Addendum No. 2

City of Coquitlam
Tender 84499

Nelson & Como Creek Flood Boxes

Issue Date: July 07, 2021

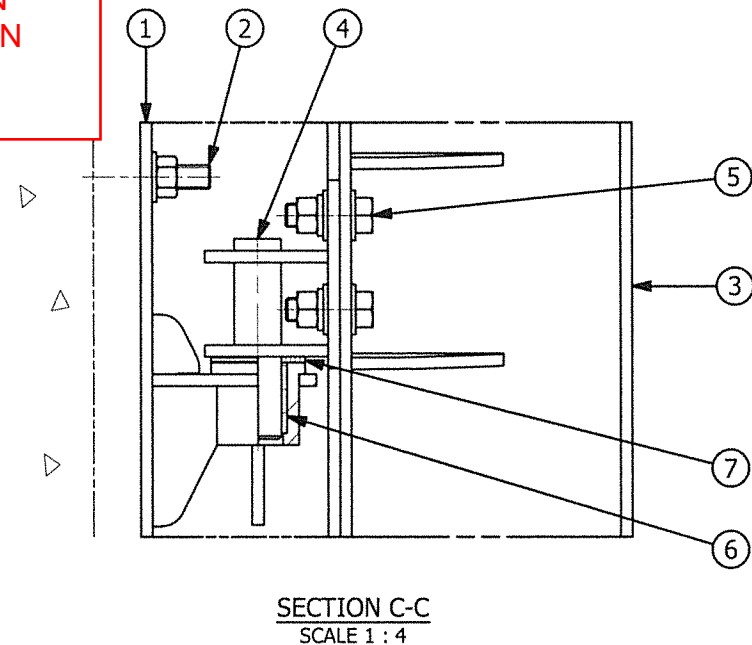
DELETE: G.H. DWG# 01 and 02

REPLACE WITH: G.H. DWG# 01 and 02

Note: These replacement drawings are the same as the originals, the only difference is they have had review stamps and notations removed or repositioned to see underlying information. Both locations will require (2) gates hinged on the outside (French door style).

HEADWALL IS DESIGNED FOR GATES TO BE HINGED ON OUTSIDE EDGE AND OPEN FROM THE CENTER LIKE FRENCH DOORS.

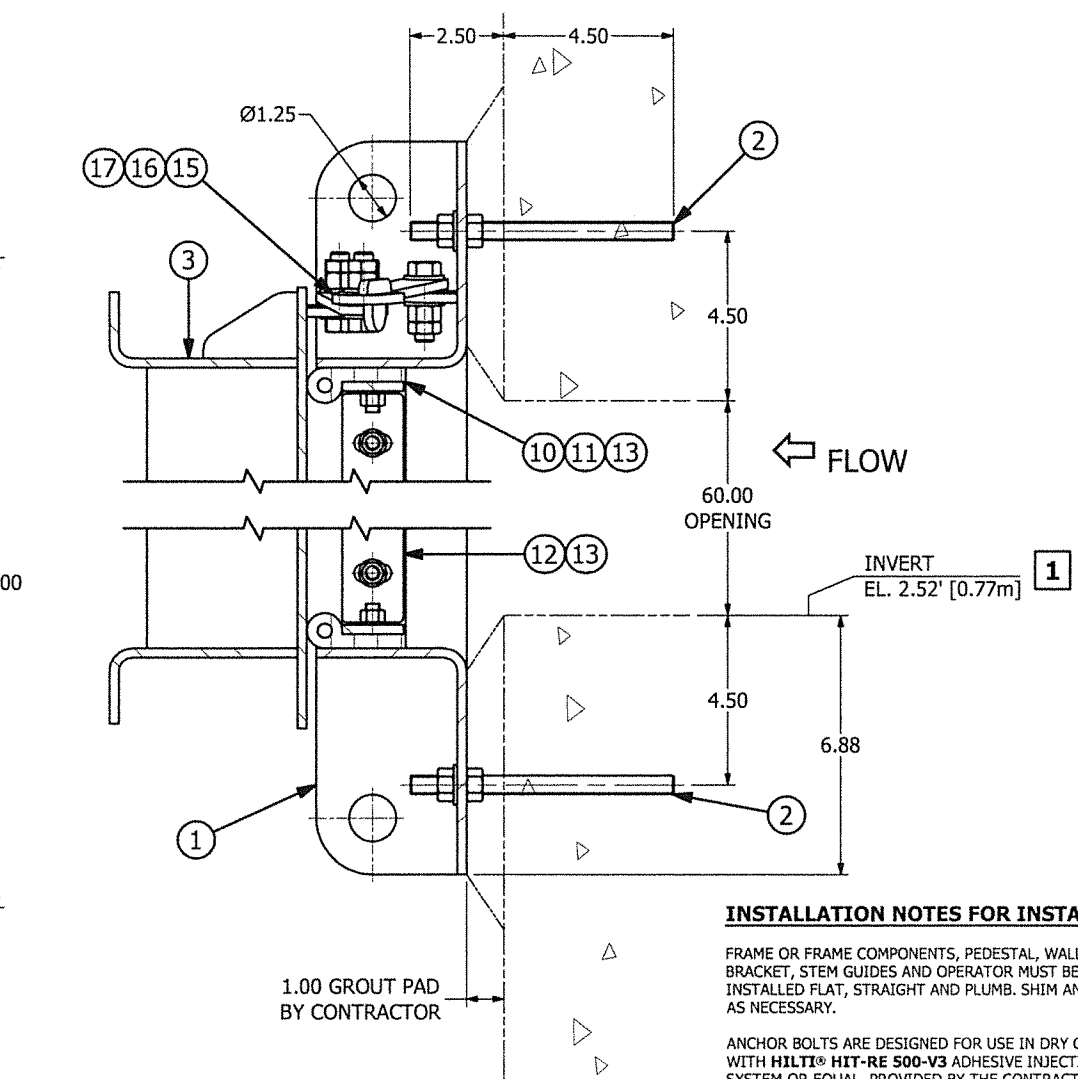
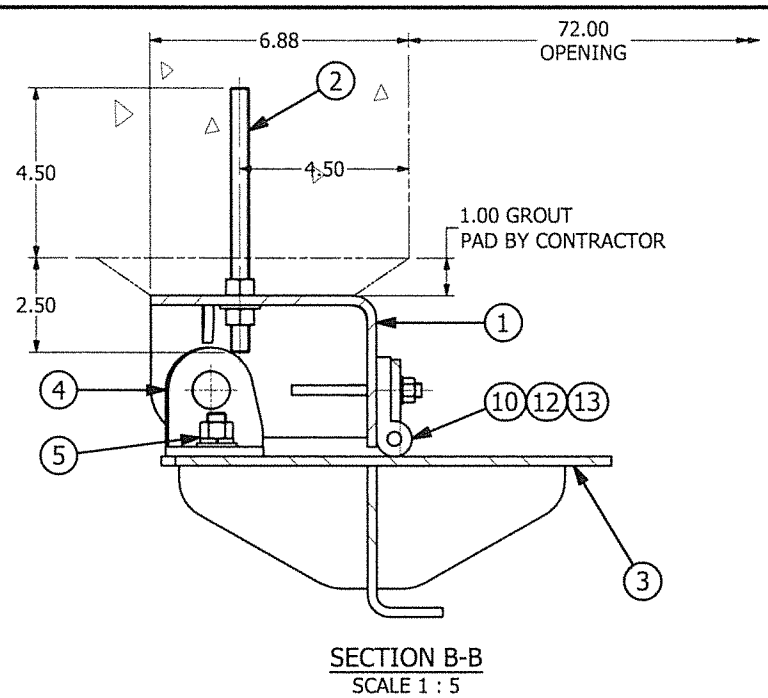
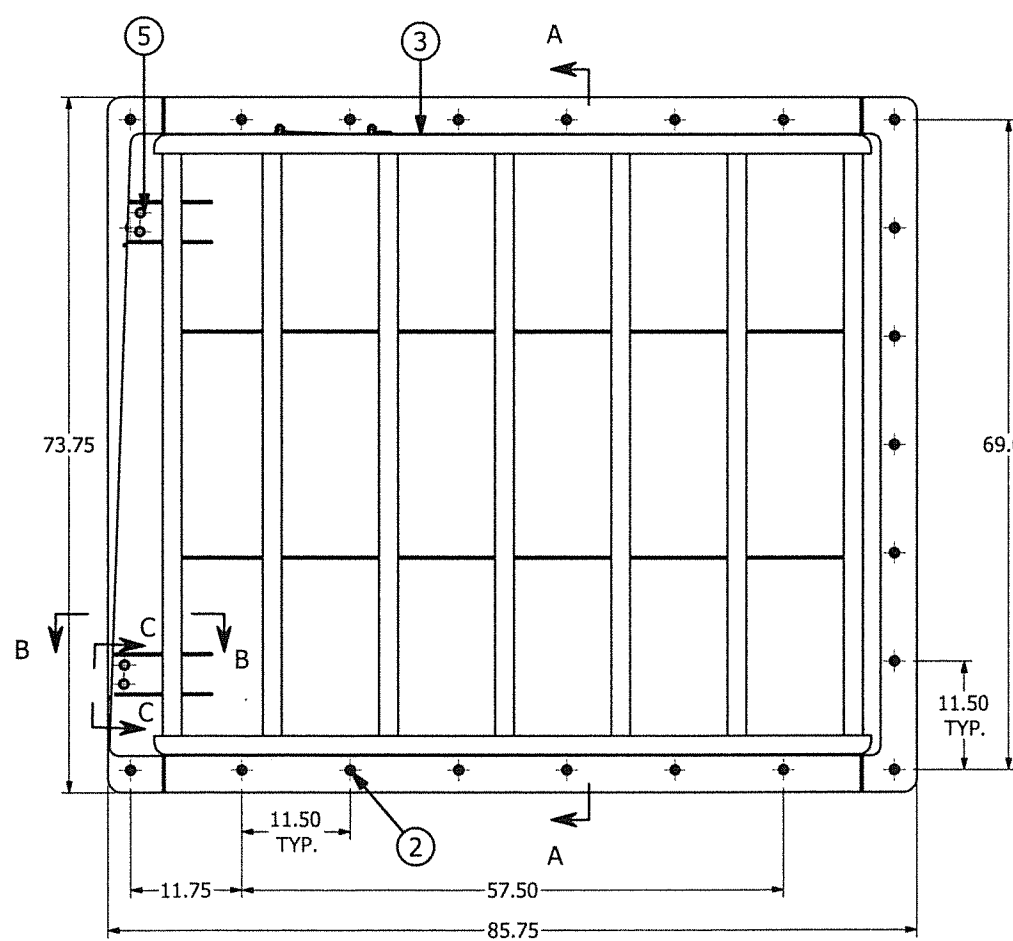
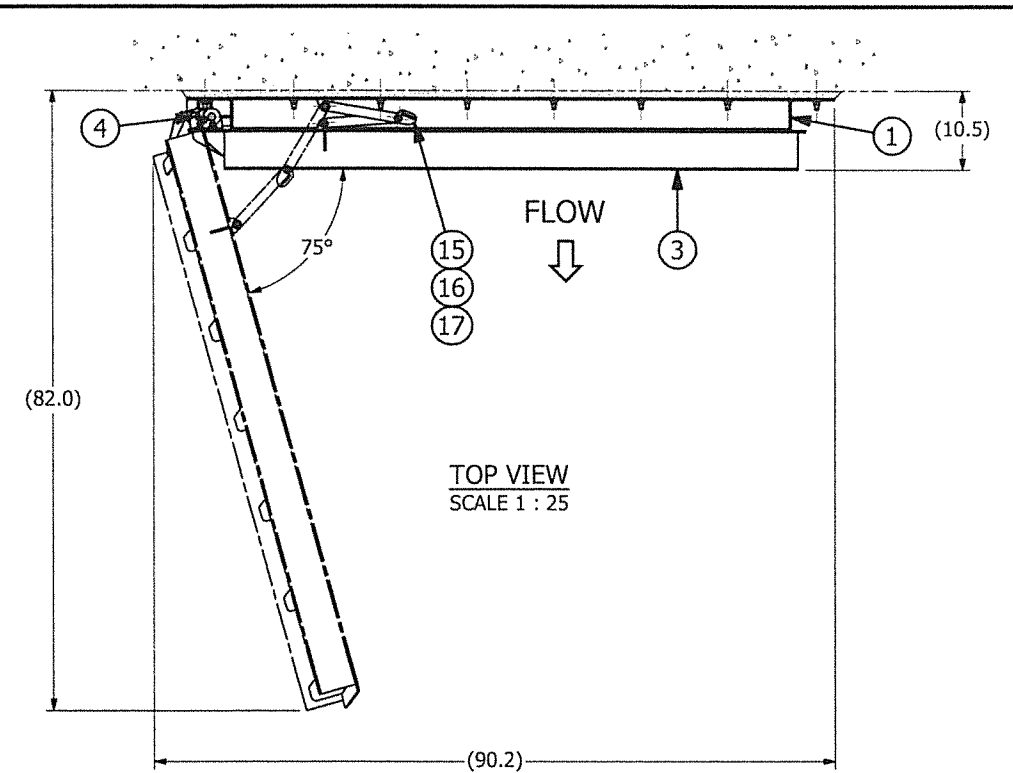
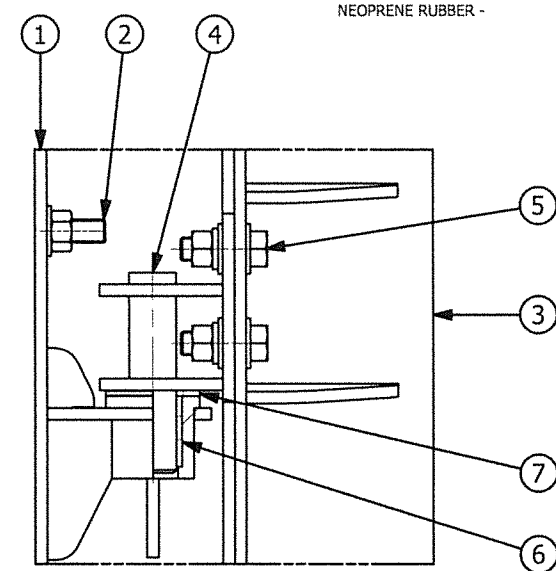
NOTE FOR CONTRACTORS:
HEADWALL IS DESIGNED FOR GATES TO BE HINGED ON OUTSIDE EDGE AND OPEN FROM THE CENTER LIKE FRENCH DOORS.
